Code Changes

Effective date: December 11, 2015

Building and Safety Standards Branch
Office of Housing and Construction Standards

9.32.3.8.

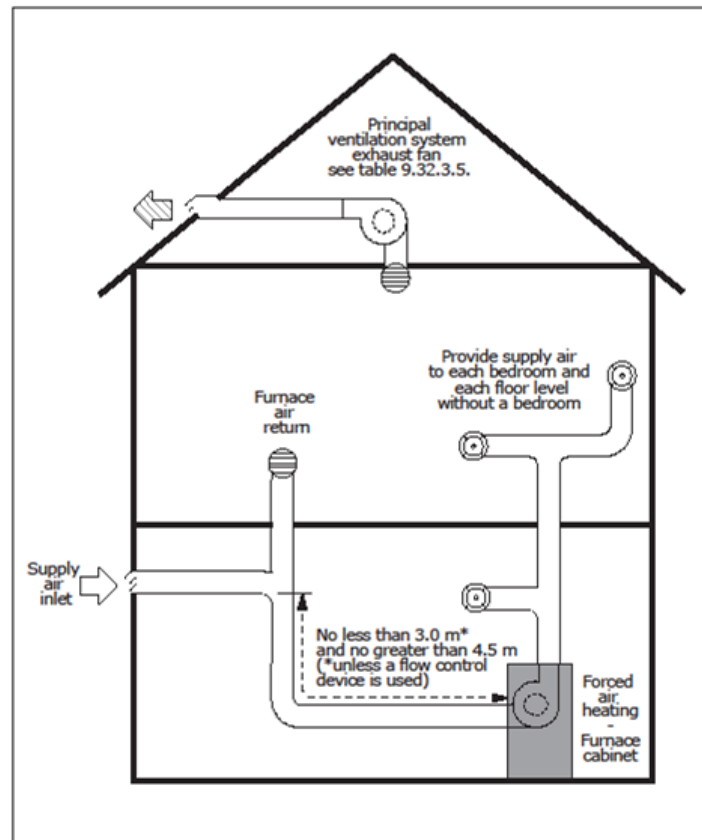
7) Except for a supply air system described in Sentence 9.32.3.4.(2) or (3), all joints in *exhaust ducts*, and in *supply ducts* that conduct conditioned air, shall be sealed against air leakage with

- a) sealants or gaskets made from liquids, mastics or heat-applied materials,
- b) mastic with embedded fabric,
- c) foil-faced butyl tape, or
- d) aluminum foil tape.

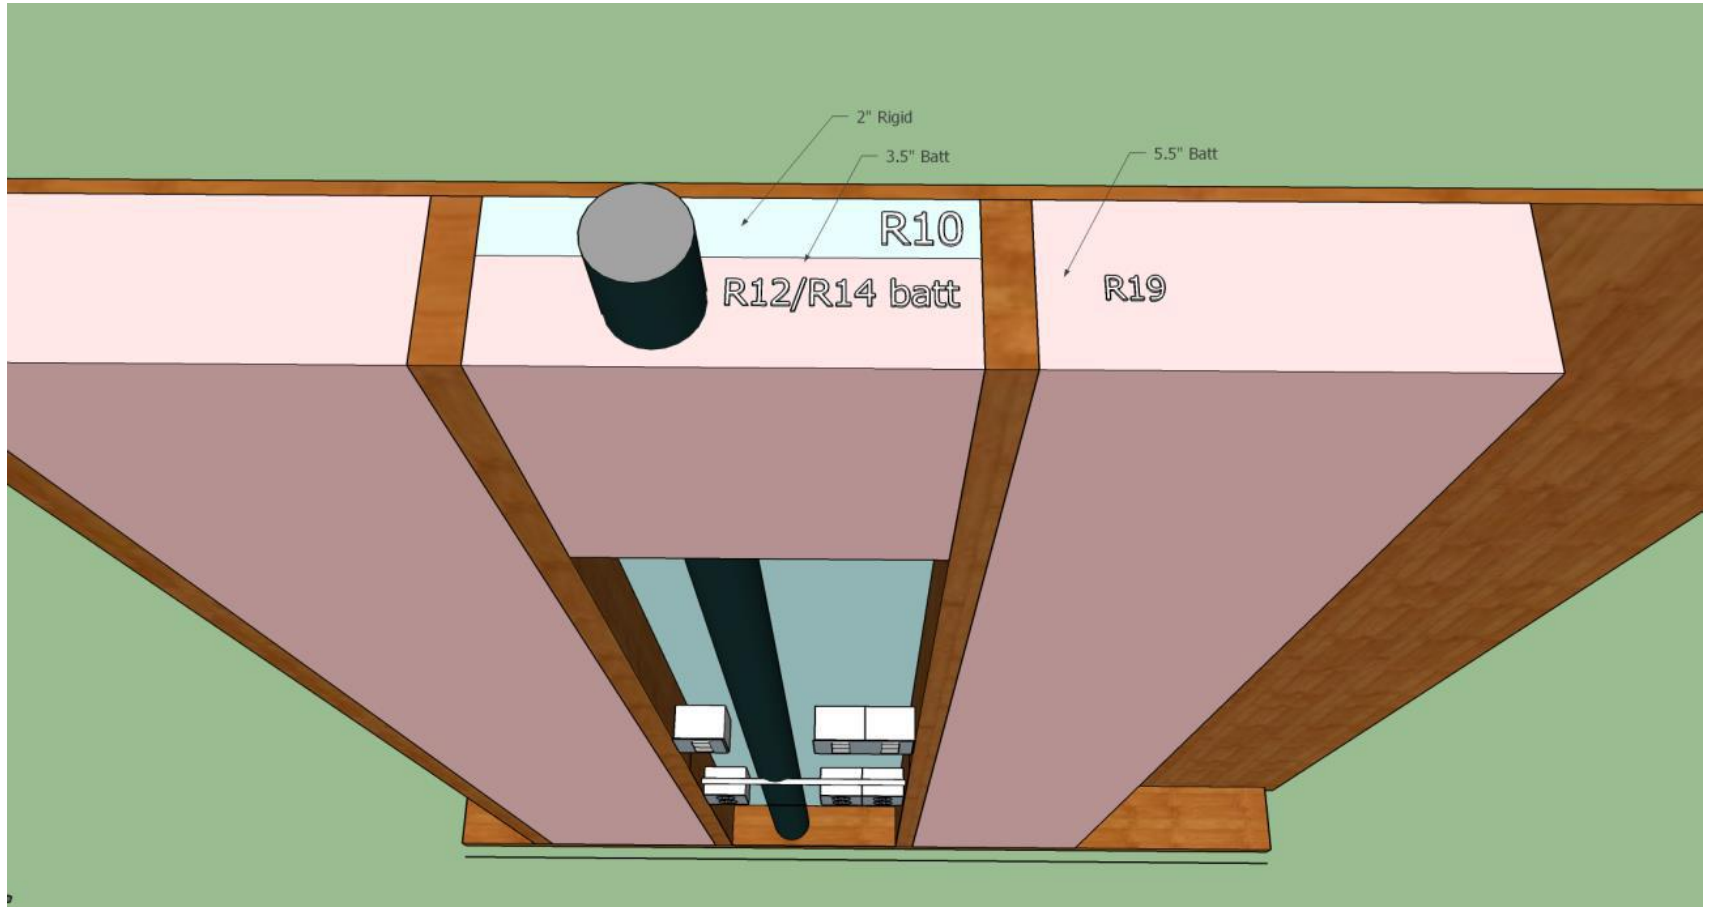
Table 9.36.2.8.A. is amended

(a) in the column headed “Zone 4” by striking out “1.96(7)” in both places and substituting “1.96”, and

(b) in the Notes to the table by repealing Note (7).

Table 9.36.2.8.B. is amended

(a) in the column headed “Zone 4” by striking out “1.96(7)” in both places and substituting “1.96”, and

(b) in the Notes to the table by repealing Note (7).
